LIST OF PROPOSED CHANGES:

THE MEADOWLANDS - PROPOSED SITE PLAN CHANGES

BUILDING 1 & 2
 PROPOSED CHANGES - FLOOR PLAN

2 NORTH ELEVATION - BLDG 3 - PROPOSED DESIGN
 PR2.3 1/8" = 1'-0"

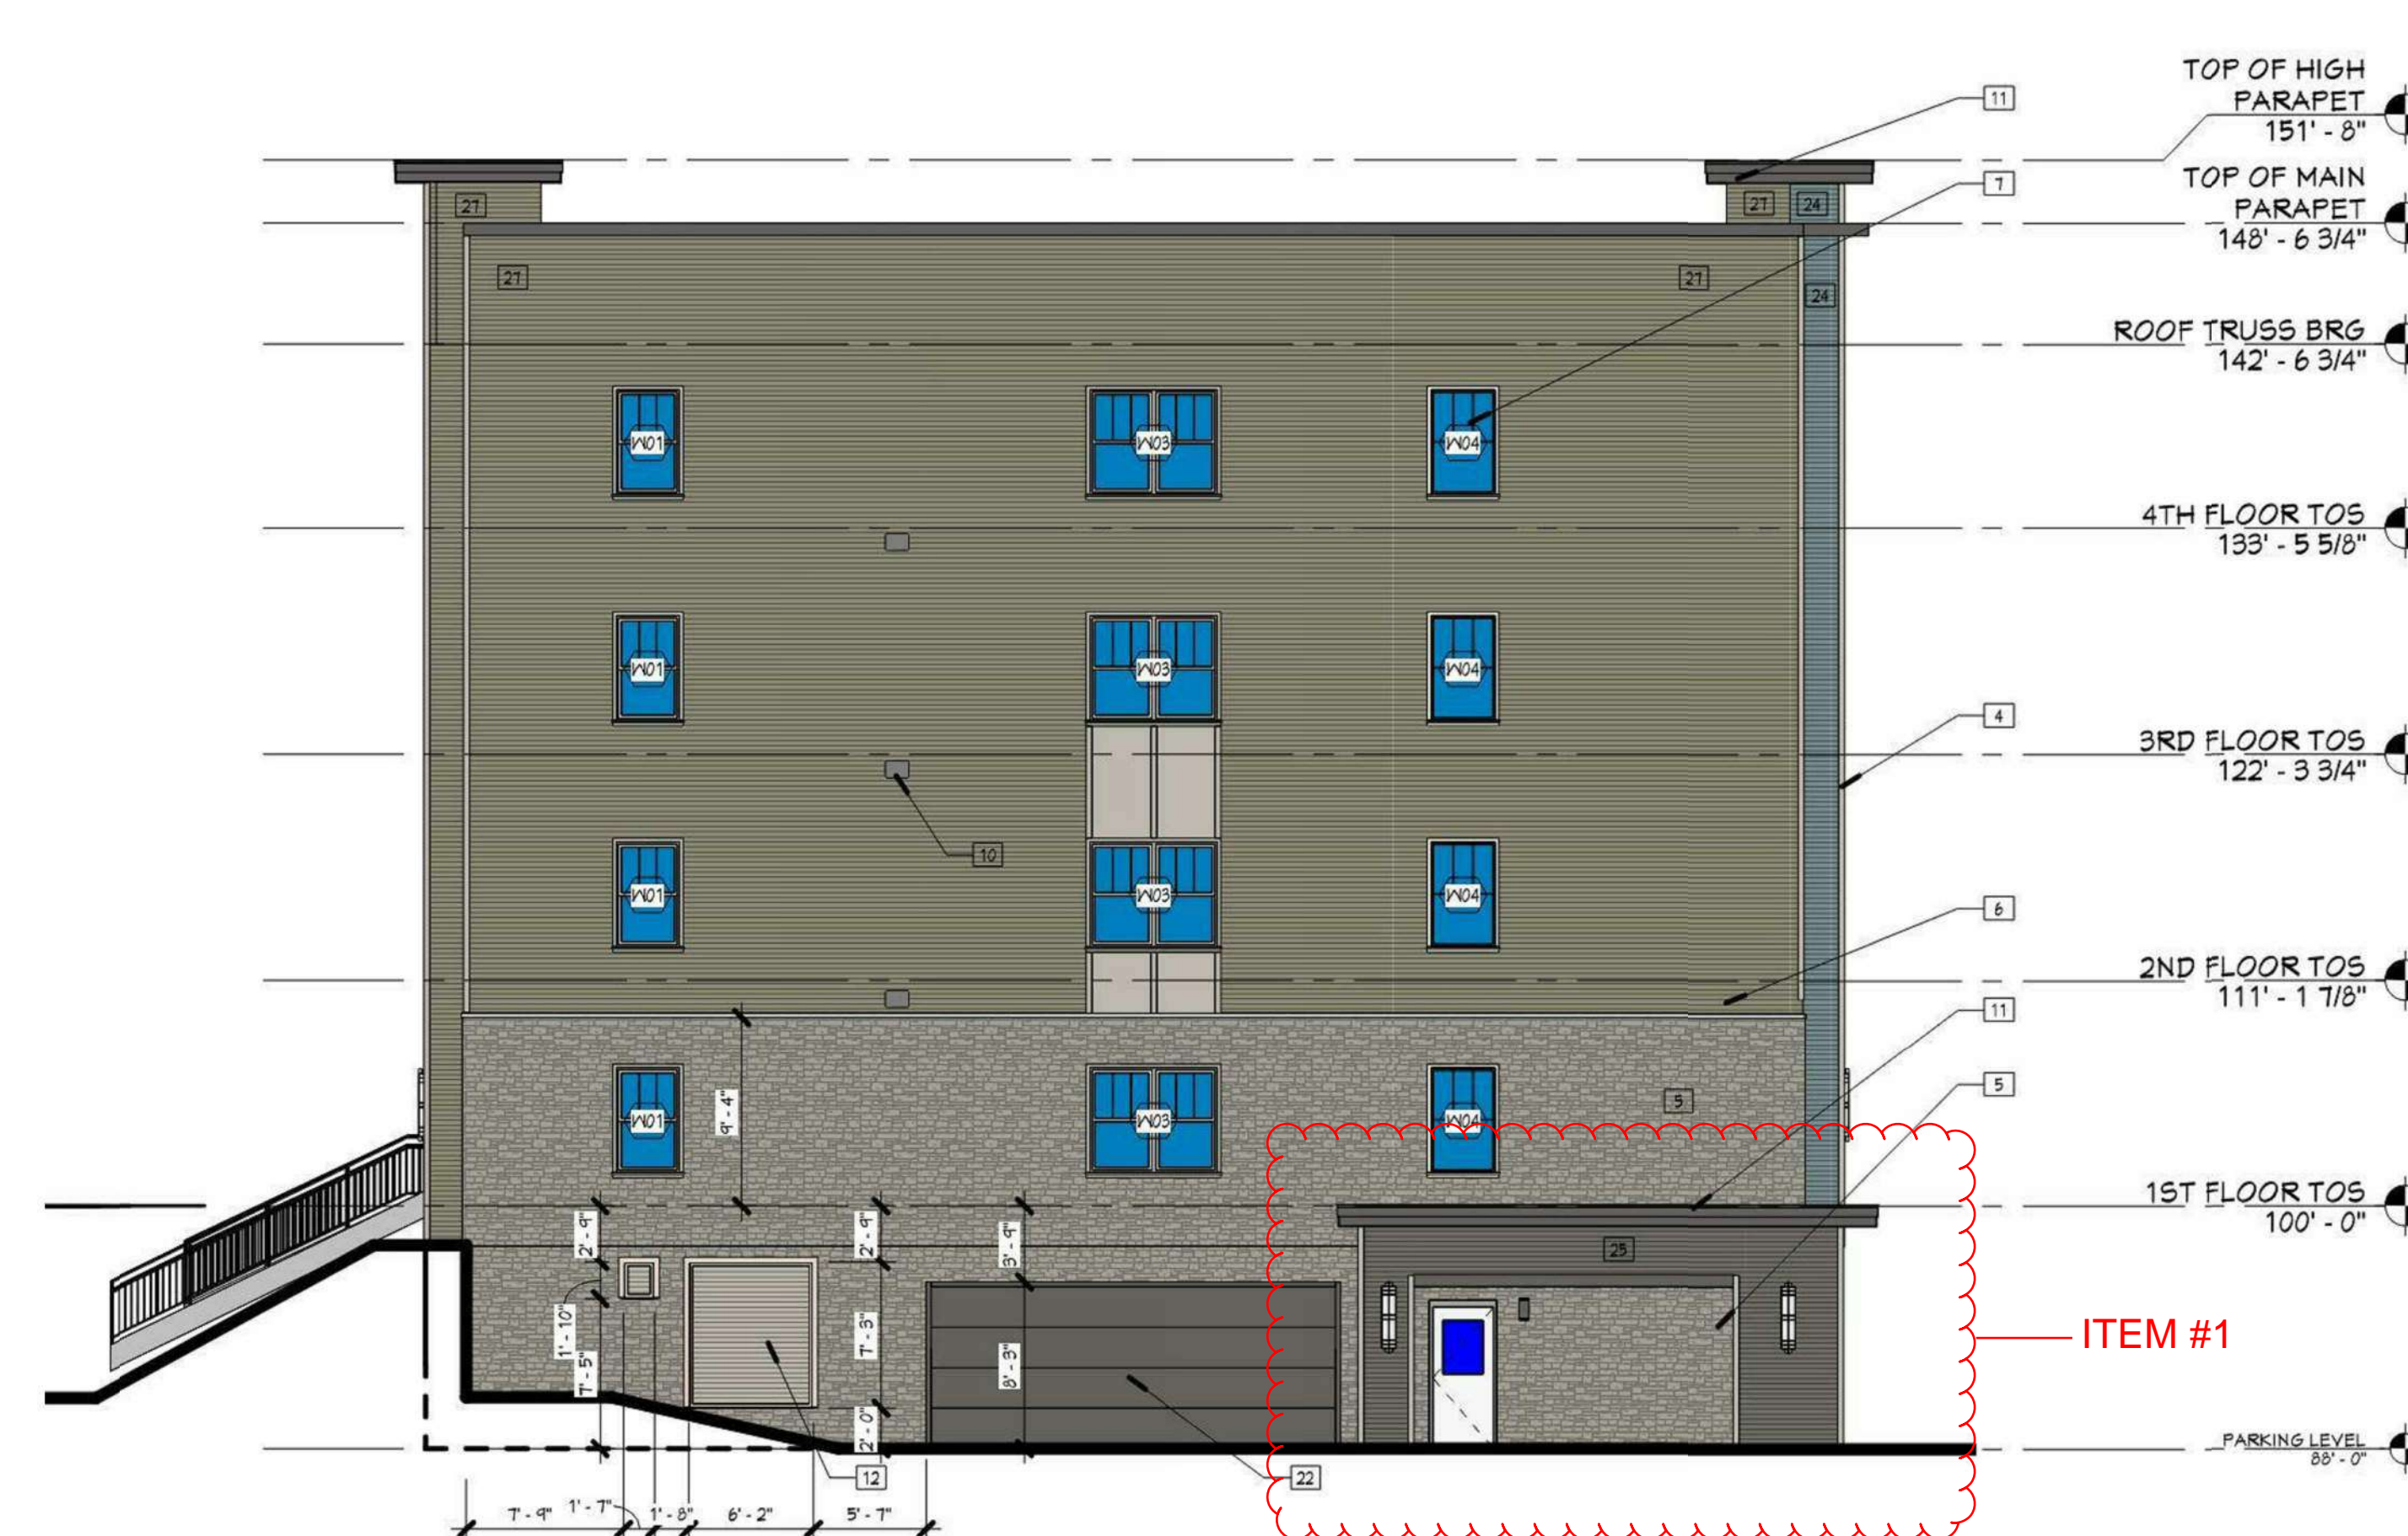
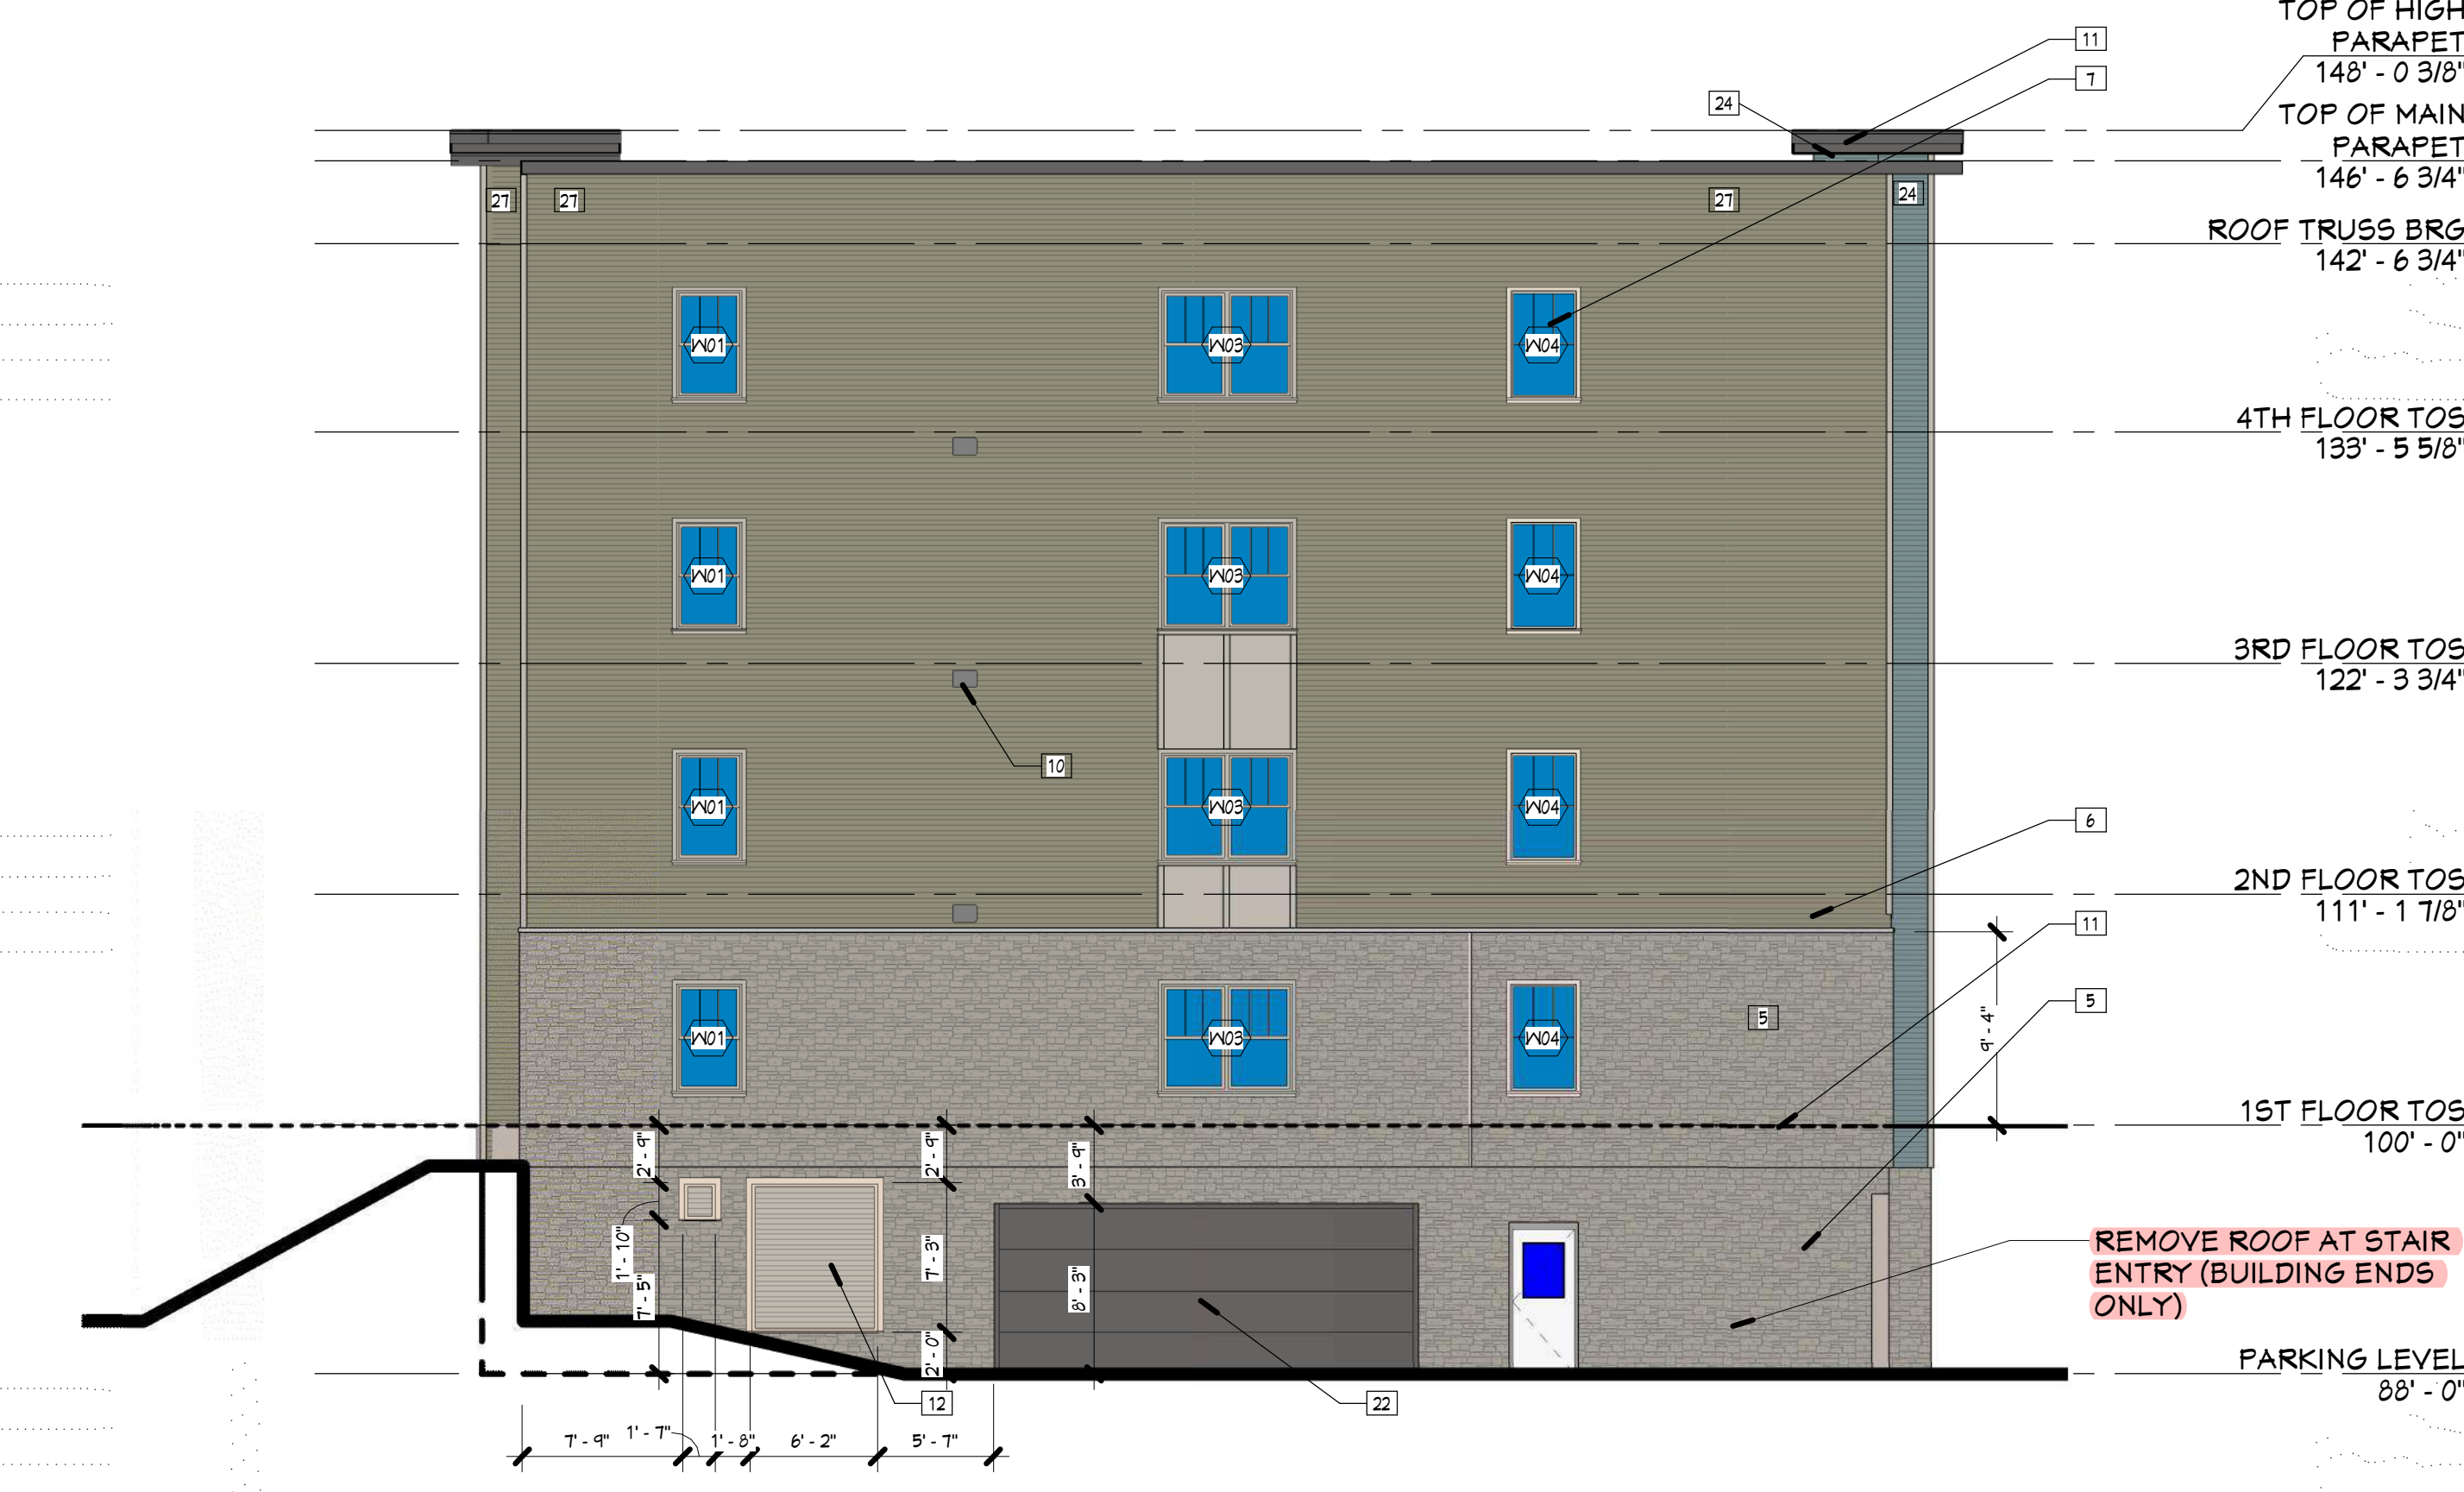
REMOVE ROOF AT STAIR ENTRY (BUILDING ENDS ONLY)

REMOVE ROOF AT STAIR ENTRY (BUILDING ENDS ONLY)
